VERSION	
GC ESP32 TFT Touch V01	
21/03/2021 1:09	
Sheet: 1/3

**GERAI CERDAS INTERNASIONAL**  
**www.geraicerdas.com**

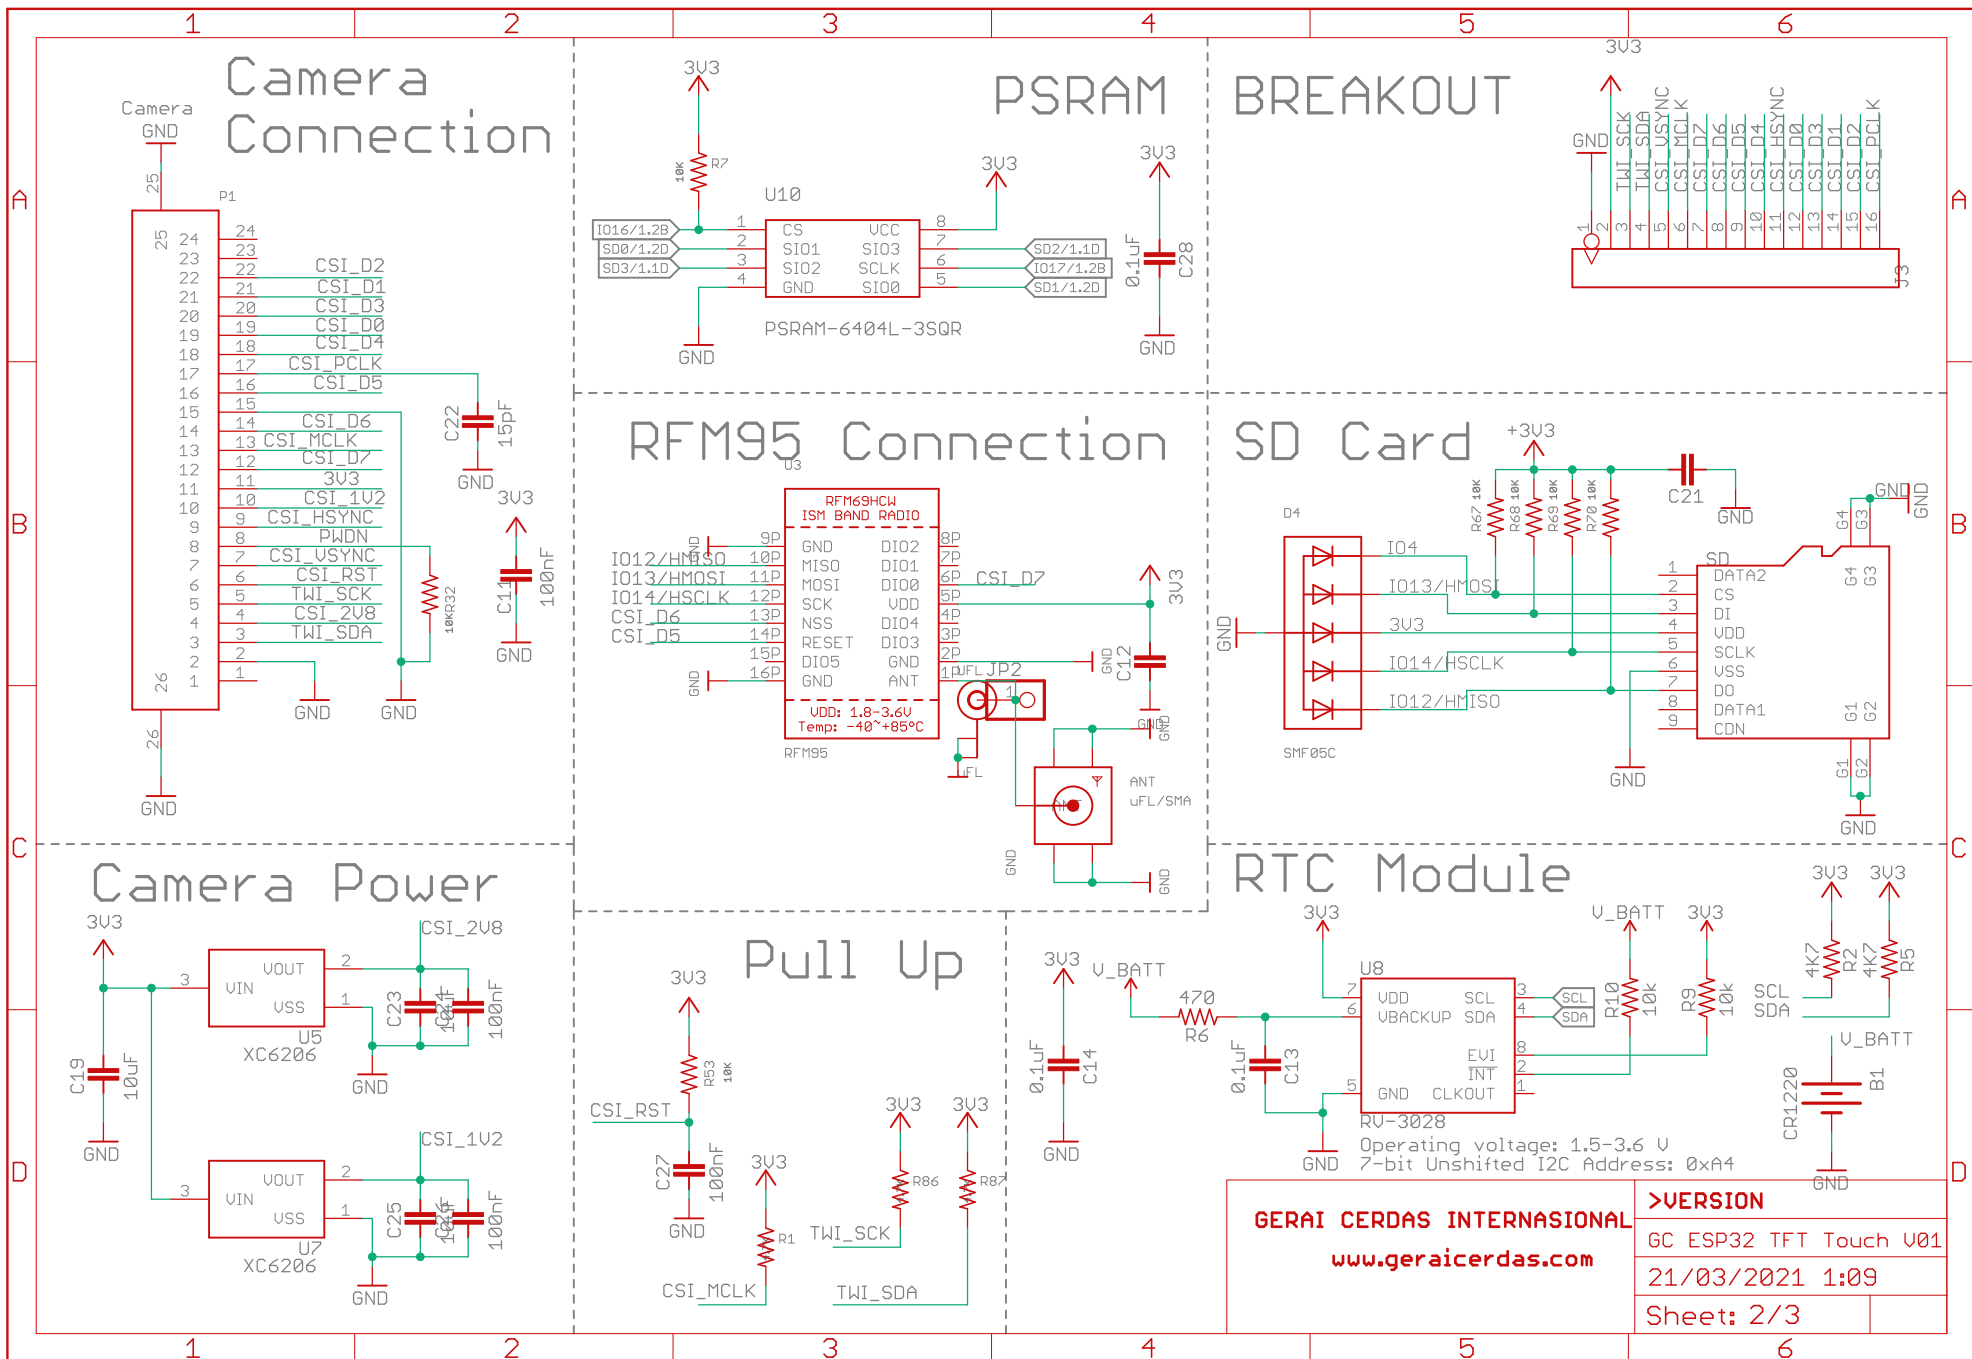
```
Before : 100nF
After  : 10uF
It should be 10uF to solve this issue :
"Timed out waiting for packet content
when uploading"
```
